Transport Access Program

Point Clare Station Upgrade

Determination Report

Figure 1-2 Key features of the Proposed Activity (indicative only, subject to detailed design)

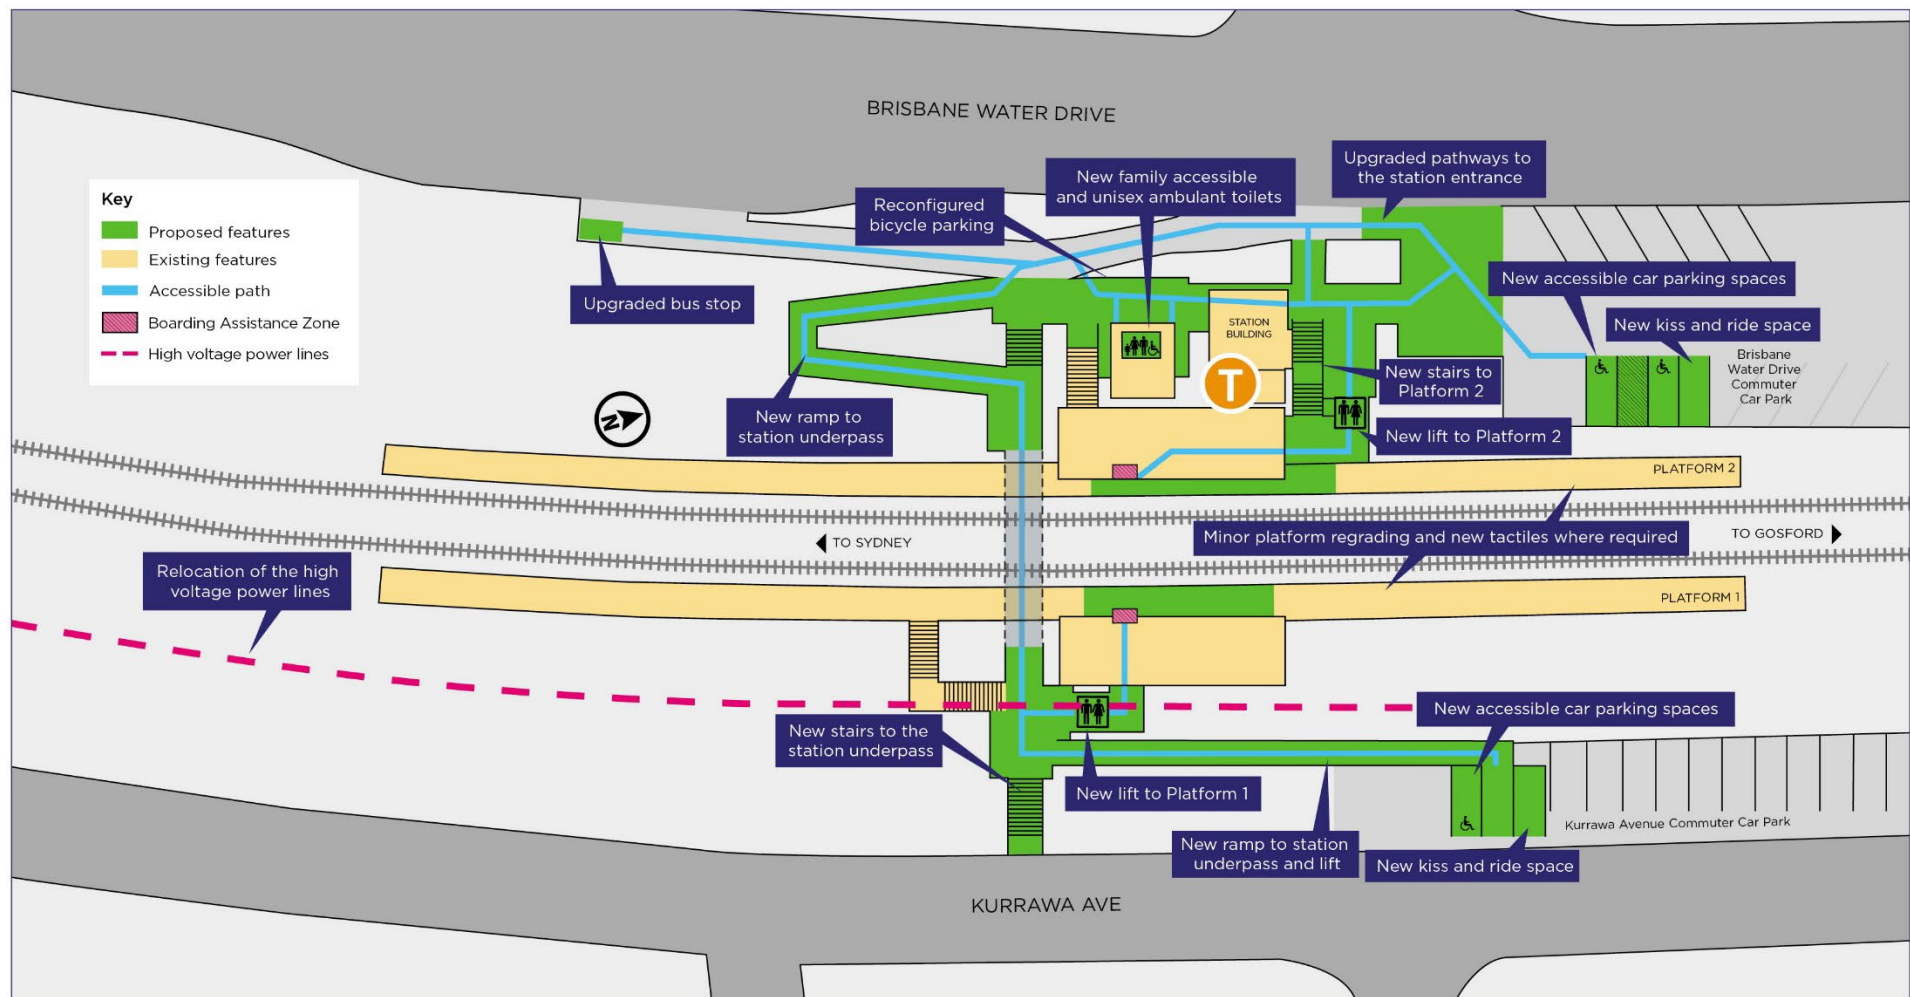
2.4	PC016 CCC	Request clarification of the zebra pedestrian crossings shown on the Proposed Activity figure	There are two existing signalised pedestrian crossings connecting the western side of Brisbane Water Drive and the station, which are not proposed to be altered as part of the proposed work. The depiction of zebra crossings in Figure 3-1 of the REF was an error.

2.5	PC016 CCC	Request clarification of the kiss and ride parking layout as they are depicted as 90 degrees in the Point Clare Station Upgrade REF despite the current car parking being at 45 degrees	<p>The new kiss and ride spaces and accessible parking spaces are indicatively shown as being perpendicular to the kerb in the REF.</p> <p>The angle, orientation and configuration of the parking arrangements would be determined as part of the detailed design process.</p>
